Re: Loup River Hydroelectric Project Relicensing  
FERC No. 1256, Docket No. 1256-029  
Platte Co.  
H.P. #0804-127-01

**Subject:** Loup Power District - Study Results Meeting

Figure 2. Distribution of nesting sandbar elevations in Lower Platte River in 2009 between River Mile 60 – 102.

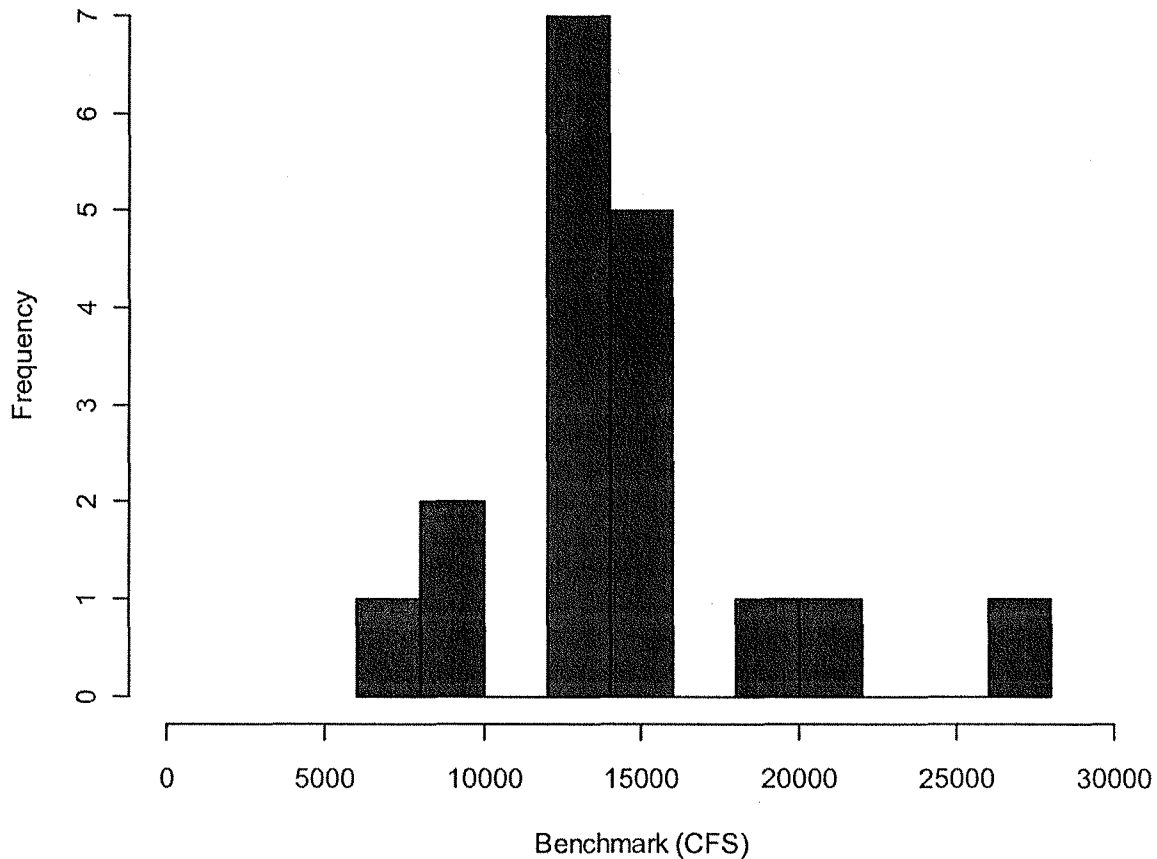
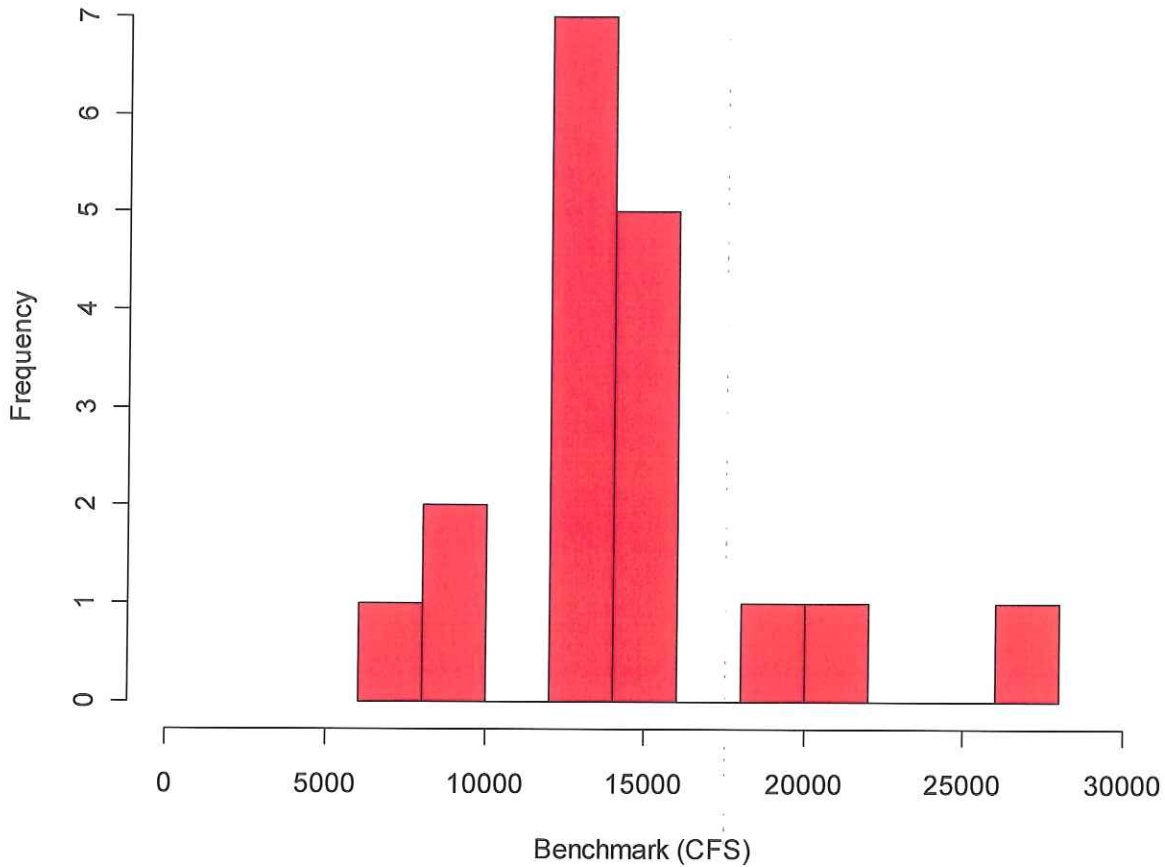
The District would also like to point out that while most of the benchmarks shown in NGPC's Figure 2 are higher than the pre-nesting season benchmark in study year 2009 (10,400), the highest flow of the season (approximately 15,100 cfs) occurred on June 17. For interior least terns, as shown in NGPC's Figure 3, re-nesting opportunities were available within the 45-day window required to fledge young before the end of the nesting season on August 15.

Figure 3: 2009 hydrograph from the 2009 study highlighting the high flow event that caused actual nest inundation. The Study results show that the difference in the peak of the current operations was 1122 cfs greater than the run of the river. Hydrocycling did inundate nests.

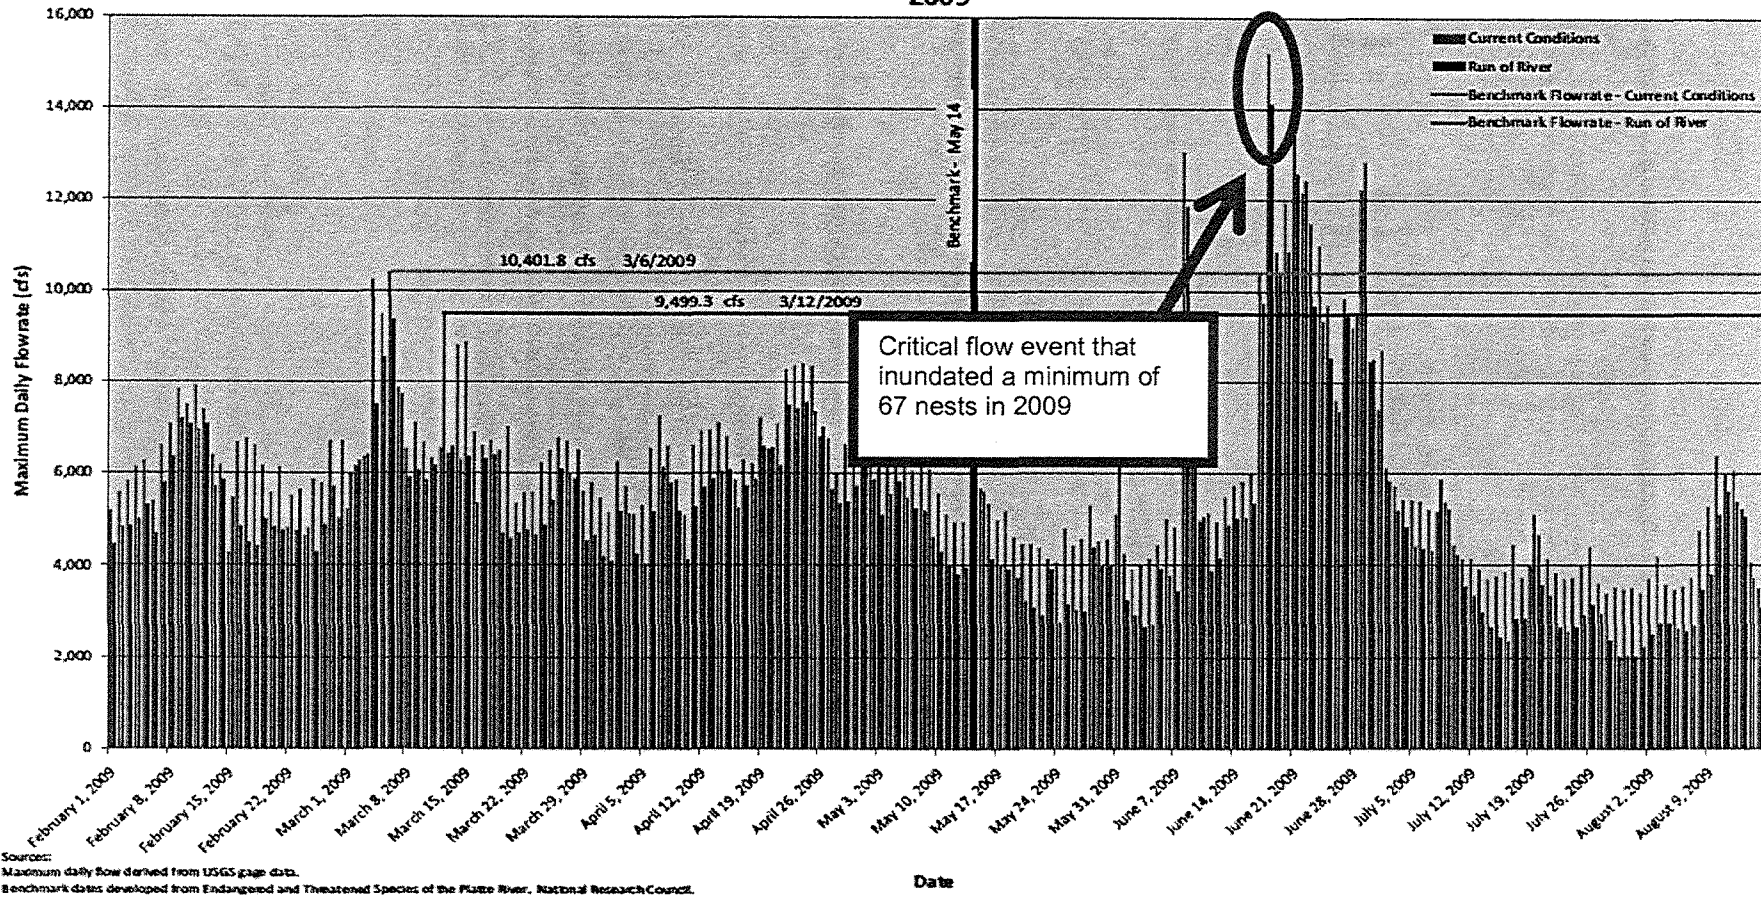
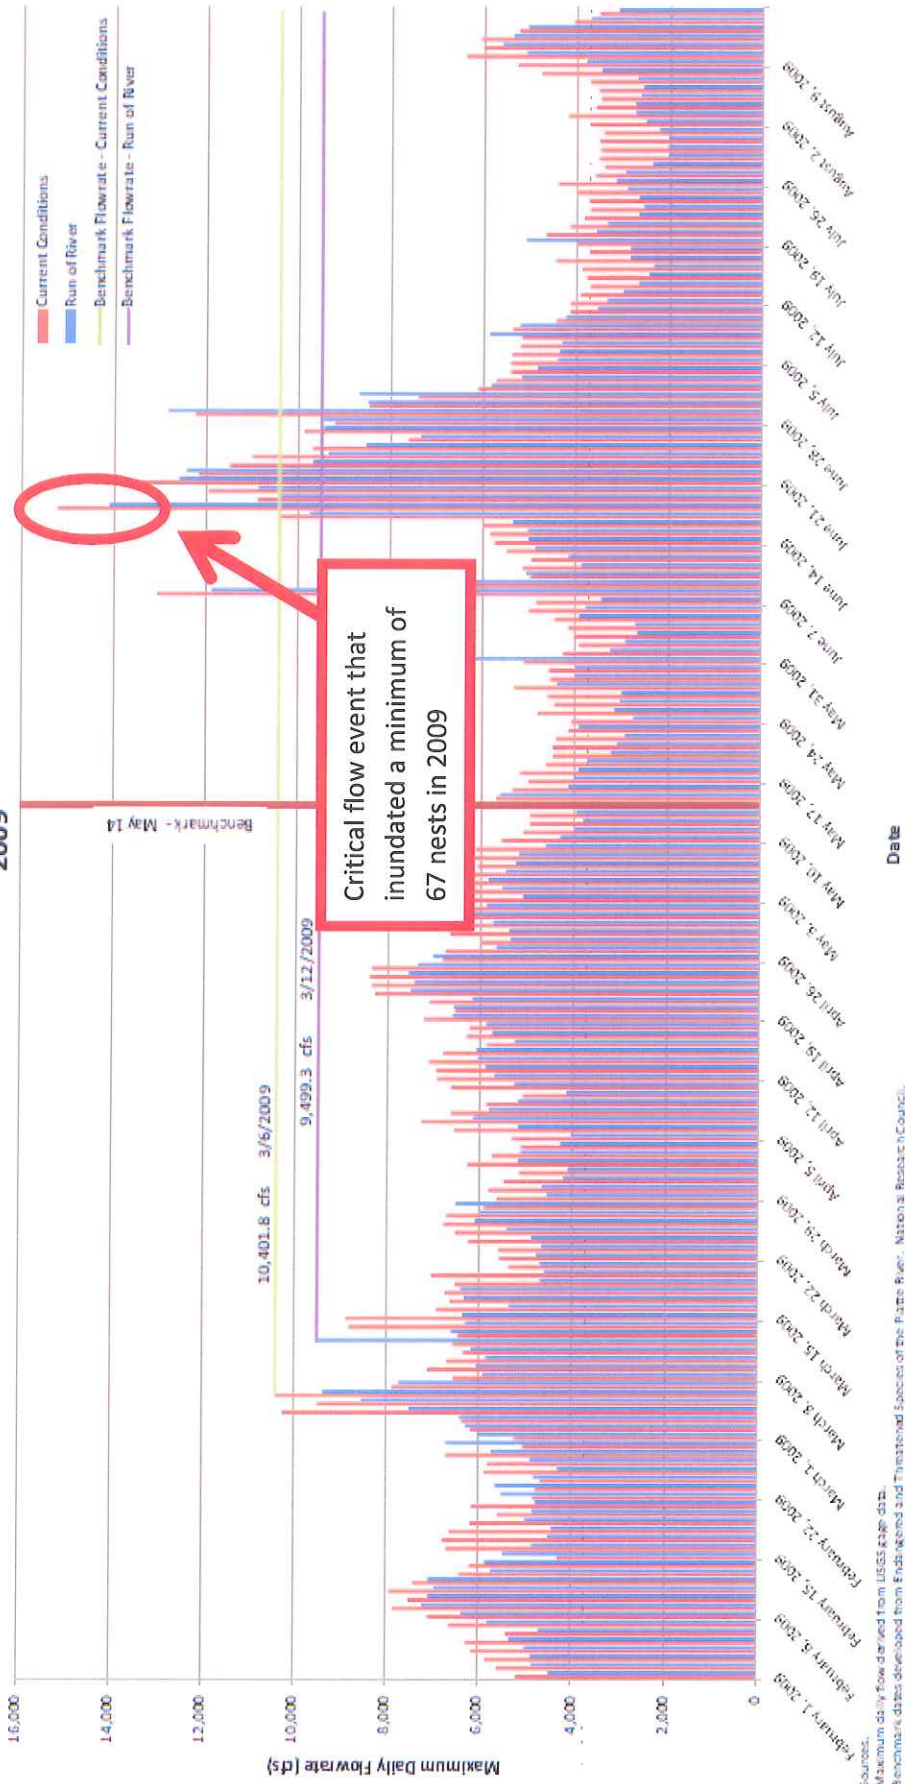
In the caption for Figure 3, NGPC states that "hydrocycling **did** inundate nests" (emphasis is theirs) and points to a critical flow event that inundated a minimum of 67 nests in 2009. The District believes this statement is misleading. As noted in Figure 3, the June 2009 peak discharge at North Bend under current operations was estimated as approximately 15,100 cfs, as compared to a run-of-river estimate of 14,000 cfs (note that both current operations and run-of-river were based on synthetic hydrographs created for the study). According to the USGS rating curve at North Bend, the difference in stage between 15,100 cfs and 14,000 cfs is 0.13 ft, or 1.5 inches. Furthermore, in reviewing the NGPC data related to nest inundation, the District notes that approximately 18 nests identified as inundated were located upstream of North Bend (RM 99 and RM 90) and the remaining nests identified as inundated were located between Leshara and Ashland. As noted in the District's SISR Study 2.0 Hydrocycling report, the increase in stage associated with hydrocycling is reduced as distance increases downstream from the Tailrace Return. Additionally, sub-basin precipitation in the lower reaches of the Platte River can, and do, contribute to hydrograph fluctuations.

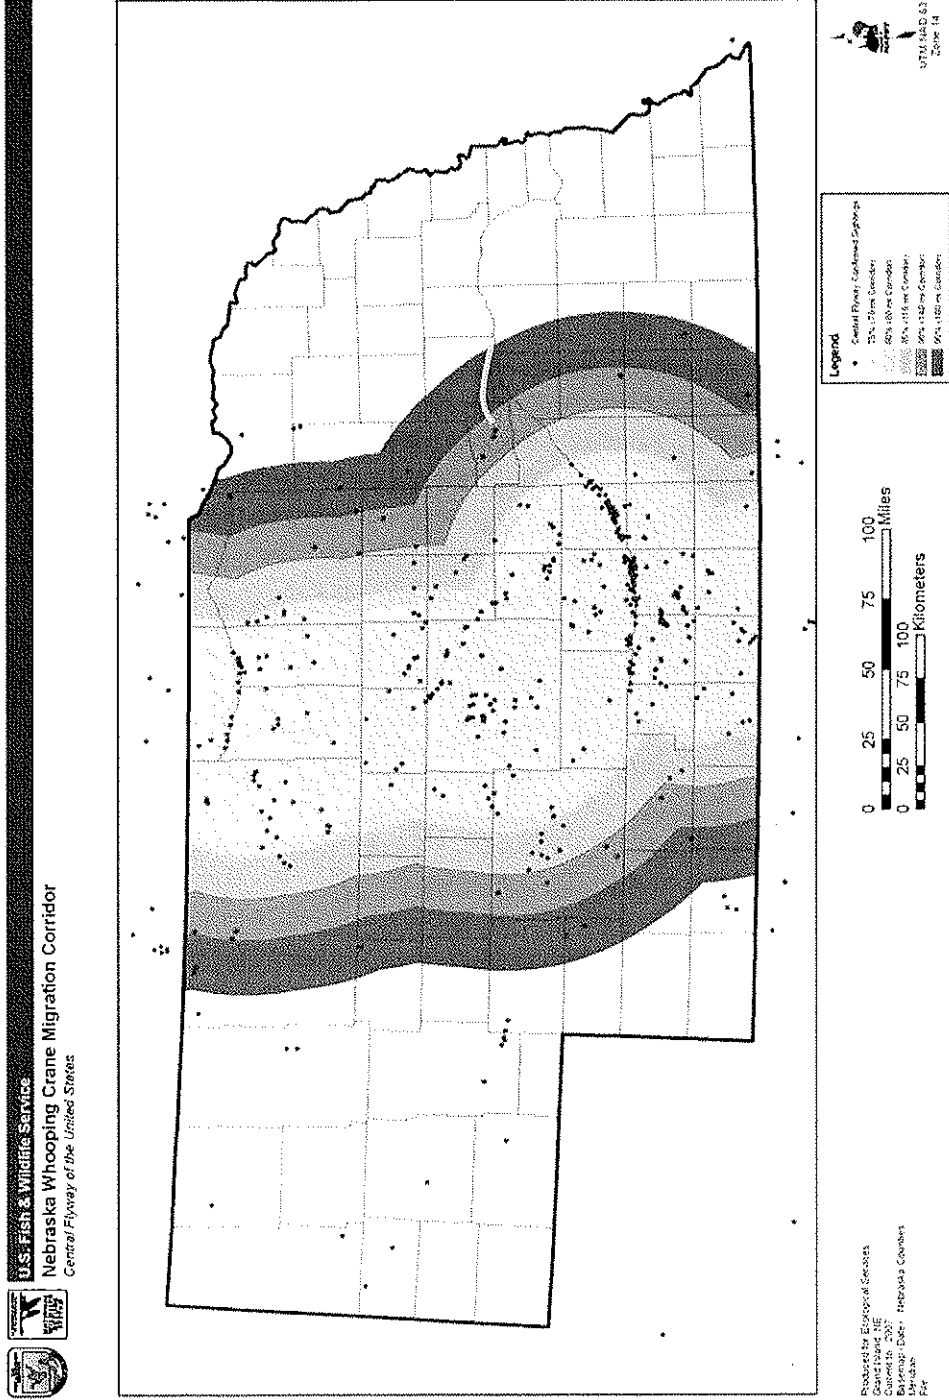
AWBP (Tacha et al. 2011). The improved mapping capabilities show that Loup River bypass is nearly contained within the eastern 95-percent boundary whooping crane migration corridor in Nebraska (Figure C-1). This would imply that 5-percent of the population migrates within the 95-percent boundary, and the Service assumes the eastern corridor represents 2.5-percent or one half of the total 5-percent. The current AWBP population estimate is 279 individuals of which 2.5-percent represents approximately seven individual whooping cranes that are likely to fly over the bypass area for both the spring and fall migrations. Based on the downlisting criteria for the AWBP is 1,000 individuals, approximately 25 individual whooping cranes are expected to fly over bypass area, for both spring and fall migration seasons, on an annual basis with the expectation of roosting along the migration route.

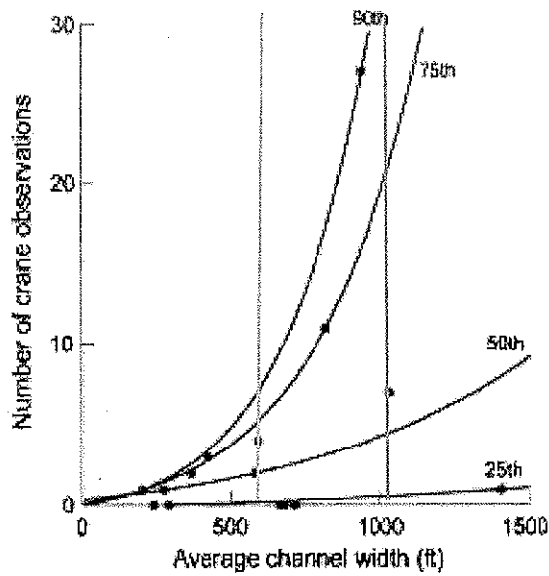
Farmer et al. (2004) concluded for the central Platte River that wide channel width was a necessary condition for a large number of whooping crane roosts to occur. Narrow channel widths precluded large numbers of use by cranes. Figure C-2 demonstrates that channel widths downstream of the Project diversion fall within the range of unobstructed channel widths that would preclude high number of whooping cranes. Unobstructed channel widths upstream of the diversion provide conditions that would allow for a much higher probability of use by the species. The Service has also applied channel width data to a suitability curve developed by Howlin et al. (2008) demonstrating that the channel width upstream of the diversion has a higher suitability compared to channel widths downstream of the diversion (Figure C-3).
